Access Compliance Report

Public Rights-of-Way

(Curb Ramps)

Intersection ID: 15956	Main Street: POINDEXTER_DR	Cross Street: SEDGEFIELD_RD	Location: E
ADA ID: 0BB9D280AE96	Ramp Type: Directional1	Initial Pass/Fail: Fail	Overall Compliance: No
Severity Score: 1.25			
Codes/Mitigation Info/Possible Solution		Field Measurements/Component Compliance

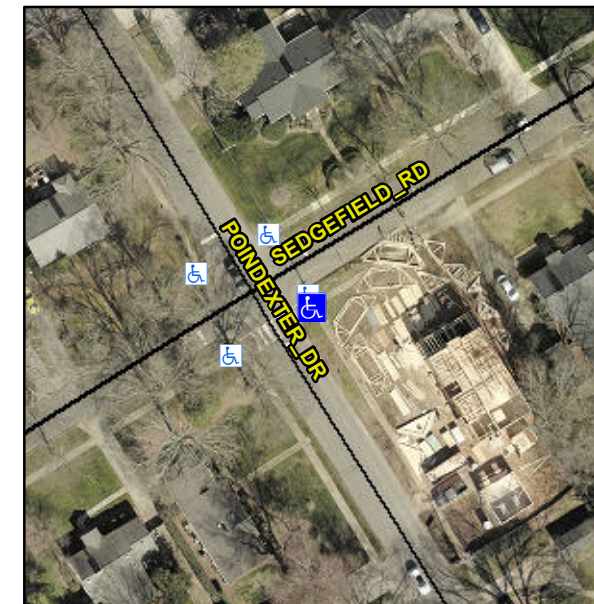
NO CURB

R304.5.3

Compliance	Description	Data	Compliance	Description	Data
N/A	Ramp Length (in)	106.0	N/A	Grade Break?	N/A
Yes	Ramp Width (in)	48.0	N/A	Grade Break Slope (%)	0.0
Yes	Ramp Slope (%)	8.3	N/A	Grade Break XSlope (%)	0.0
No	Ramp XSlope (%)	3.1			
N/A	Flare Type LT	N/A	N/A	Flare Type RT	N/A
N/A	Flare Slope LT (%)	N/A	N/A	Flare Slope RT (%)	0.0
N/A	Flare Traversable LT?	N/A	N/A	Flare Traversable RT?	N/A
N/A	Landing Length (in)	0.0	N/A	DWS Provided?	N/A
N/A	Landing Width (in)	0.0	N/A	DWS Contrast?	N/A
N/A	Landing Slope (%)	0.0	N/A	DWS Length (in)	N/A
N/A	Landing X Slope (%)	0.0	N/A	DWS Full Width?	N/A
N/A	Landing Curb? (Y/N)	N/A	N/A	DWS Offset LT (in)	N/A
N/A	Shared Landing?	N/A	N/A	DWS Offset RT (in)	N/A
N/A	Gutter Ponding?	0.0	N/A	Gutter Slope (%)	N/A
N/A	Gutter Lip Ht (in)	0.0	N/A	Gutter X Slope (%)	N/A
N/A	Painted X Walk1?	Yes		Road Slope (%)	1.9
	X Walk 1 Direction	To SW		Road X Slope (%)	2.5
	X Walk 1 Width (in)	113.0		Clear Space?	N/A

Remove & Replace Entire Ramp.
